PHASE 1A LAND DEVELOPMENT PLAN REVIEW LETTER #3

MIDDLESEX TOWNSHIP, CUMBERLAND COUNTY, PA

Preliminary Land Development Plan for Pennsylvania Digital 1 (PAX-1) Phase 1-A

January 23, 2026

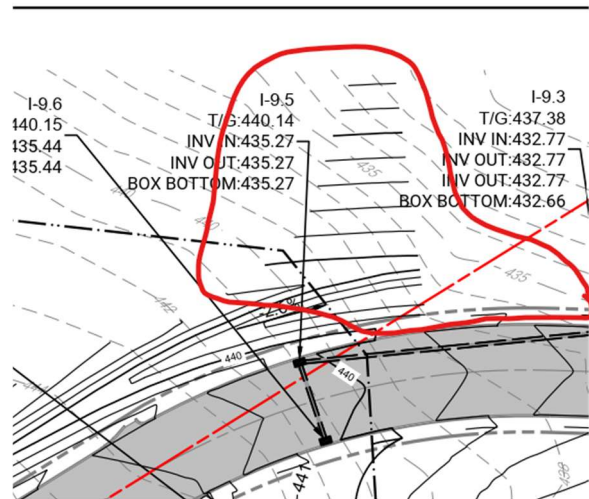
4. Provide a min. 20' wide drainage easement with metes and bounds along all stormwater management facilities, channels and inlets [303.J.12 & 303.K.12].* The applicant has indicated that they will provide the easements on the final plan. This must be shown on the preliminary plan in accordance with the Subdivision and Land Development Ordinance Section 501.C.19.
5. Ensure all proposed contour lines tie into existing contour lines and all proposed contours are shown. For example, the proposed contour lines at the western and northern access do not appear to be complete. [302.A.18].* The proposed contour lines still do not appear to tie into existing contours lines along the north side on PA Data Drive and at the two driveways to Phase IB and 2. See image to the right for example.
